PRODUCT CHANGE NOTIFICATION

#PCN-DC-ODDV-15

Previous Product	New Product
	<p><u>Female</u></p>  <ul style="list-style-type: none"> Groove on the contact carrier and chamfer on the nut Shortened coding groove Adjustment to standardized dimension of $8,2^{-0,15}$ Removal of the inscription of number of poles

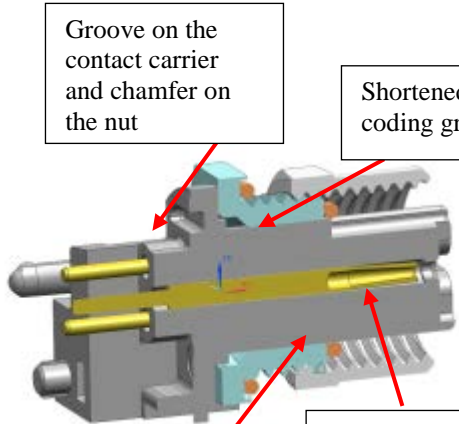
An additional groove has been added to the contact carrier of the female M12 for installation of an optional O-ring. This new O-ring is intended to increase the optimal tightness for sealing of the connector when in the unmated state. The chamfer of the housing nut will be increased to accommodate the new O-ring. The coding groove will be slightly shortened for a better positioning of the O-ring. Other changes include adjustment of the contact carrier's diameter to 8.2mm and removal of the inscription of the number of poles on the mating side.
